STAFF RECOMMENDATION

308-310 Broadway

August 18, 2021

Application: Alteration—Windows, Lighting, and Signage

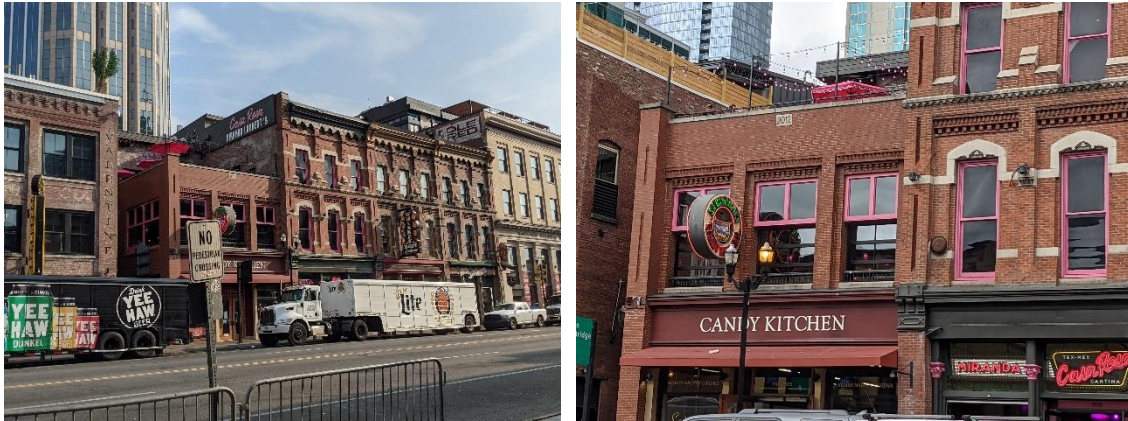
Figures 1 and 2 show the front façade of 308-310 Broadway.

Figure 3. Completed work.

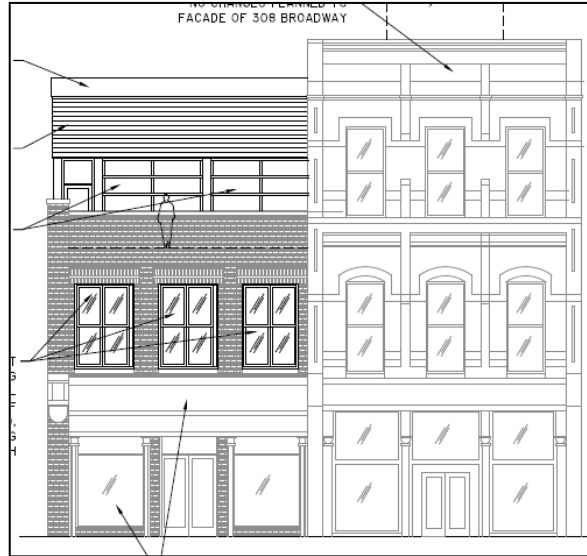
Windows: Windows were installed on the second-level of the front façade without a permit and include fixed and roll up windows. (See Figures 2 and 3). According to Section II.A.4, replacement windows should be should have single-light or multiple-light clear-glass panes to match the style and period of the building. In this case, a single or double hung window would be appropriate for the style of the building (Figure 4). Roll up doors on upper levels are not seen in the district historically, and the Commission has not approved such windows for upper levels, or for Broadway facing elevations, in the past.

Recommendation Summary: Staff recommends disapproval of the windows and lighting, finding that they do not meet Section II and Section III. of the design guidelines for Rehabilitation. Staff recommends that the unpermitted windows and lighting with the associated poles be removed and the menu signs changed to not exceed a total of five square feet (5 sq. ft.) within 60 days of the Commission’s decision.
